SITE INSTRUCTION

PROJECT: HAMPTON MANOR
25 BAKER HILL BLVD
STOUFFVILLE, ONTARIO

SITE INSTRUCTION: M-19

Purpose: Revise generator layout at mechanical penthouse.

TITLE PENTHOUSE FLOOR PLAN MECHANICAL			
PROJECT 25 BAKER HILL BLVD. ROYAL PINE HOMES STOUFFVILLE, ONTARIO PROPOSED RESIDENTIAL DEVELOPMENT			
DRAWN GC		CHECKED BT	
DATE JUNE 2015		PROJECT 14-016	
		SCALE 1:50 DRAWING M-34 OF 42

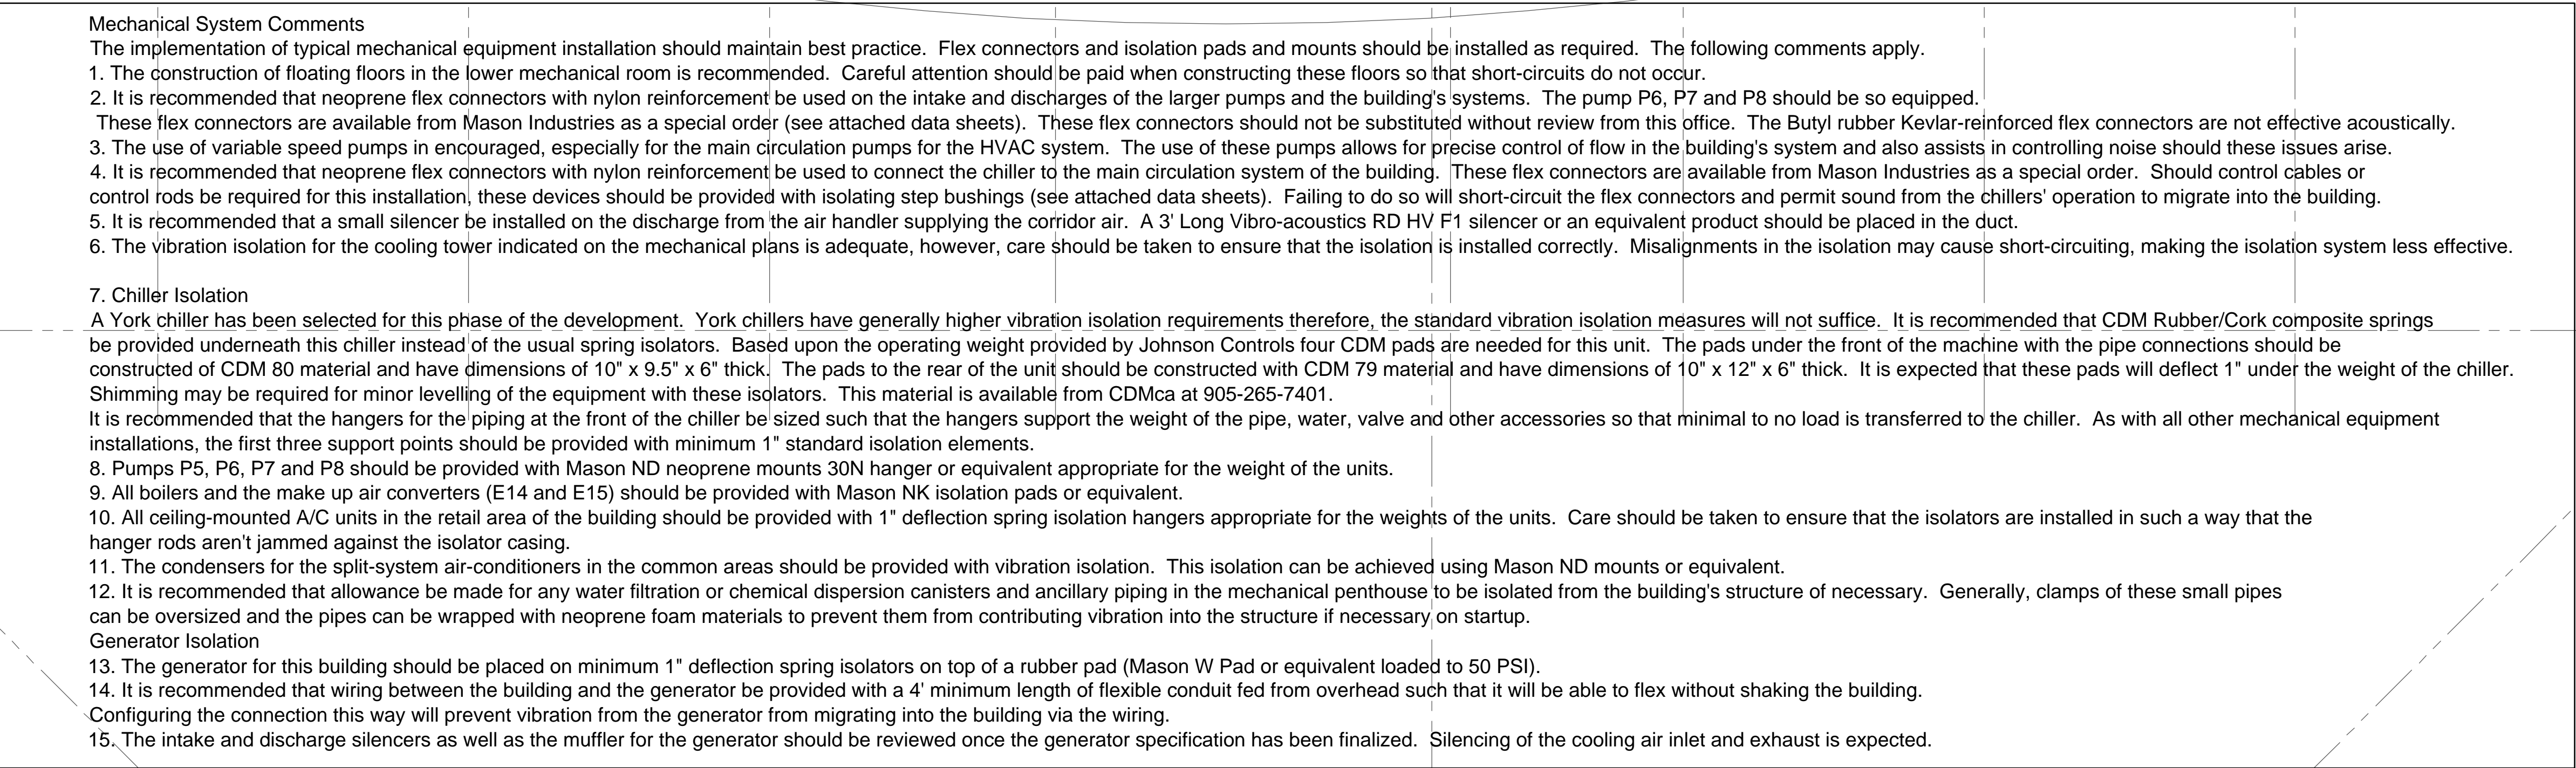
1.0 Reference Drawing M-34 (Mech Penthouse) Issued

1.1 Revised: Generator layout.
